Access Compliance Report

Public Rights-of-Way

(Curb Ramps)

Intersection ID: 11234	Main Street: FLORIDA_AV	Cross Street: SHAMROCK_DR	Location: S
ADA ID: E439C4840B4D	Ramp Type: PerpDiag	Initial Pass/Fail: Fail	Overall Compliance: No
		Severity Score: 37.5

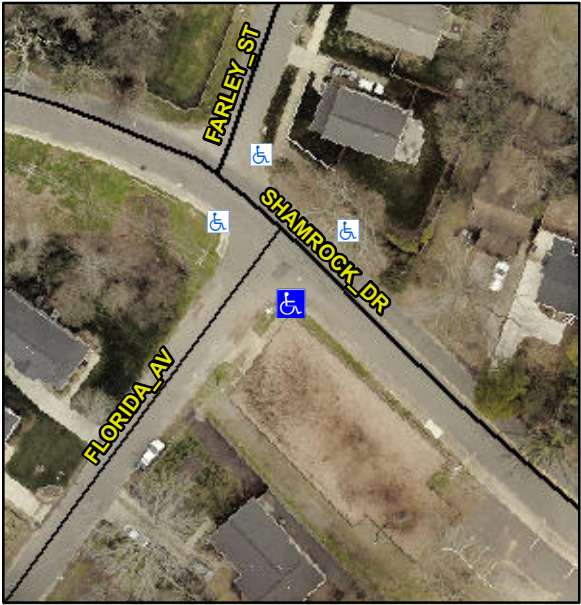
Codes/Mitigation Info/Possible Solution		Field Measurements/Component Compliance			
	Possible Solutions:	Compliance	Description	Data	
	Remove & Replace Curb Ramp With Two New Directional Ramps or Equivalent.	N/A	Ramp Length (in)	57.0	No
		Yes	Ramp Width (in)	48.0	No
		N/A	Flare Type LT	N/A	N/A
		N/A	Flare Slope LT (%)	N/A	N/A
		N/A	Flare Traversable LT?	N/A	N/A
		N/A	Landing Length (in)	N/A	N/A
		N/A	Landing Width (in)	N/A	N/A
		N/A	Landing Slope (%)	N/A	N/A
		N/A	Landing X Slope (%)	N/A	N/A
<p>Surveyor Notes:</p> <p>N/A</p> <p>PROW/ADA:</p> <p>Not Found, R304.2.2, R304.5.3</p>		N/A	Flare Type RT	N/A	N/A
		N/A	Flare Slope RT (%)	N/A	N/A
		N/A	Flare Traversable RT?	N/A	N/A
		N/A	DWS Provided?	N/A	N/A
		N/A	DWS Contrast?	N/A	N/A
		N/A	DWS Length (in)	N/A	N/A
		N/A	DWS Full Width?	N/A	N/A
		N/A	DWS Offset (in)	N/A	N/A
		N/A	Shared Landing?	N/A	N/A
		N/A	Gutter Ponding?	N/A	N/A
		N/A	Gutter Lip Ht (in)	N/A	N/A
		N/A	Painted X Walk1?	No	N/A

X Walk 1 Direction	To NE	To NW
		N/A	X Walk 1 Width (in)	N/A	N/A
			X Walk 1 Slope (%)	5.2	X Walk 2 Slope (%)
			X Walk 1 X Slope (%)	0.5	X Walk 2 X Slope (%)
		N/A	Ramp inside XWalk1?	N/A	N/A
			Road Slope (%)	7.3	N/A
			Road X Slope (%)	9.9	N/A
		N/A	Any Obstructions?	N/A	N/A
Total Cost:		\$	3200.00		
			Obstruction Type		
				N/A	N/A
				Yes	Surface Condition? (G/P)
					Good
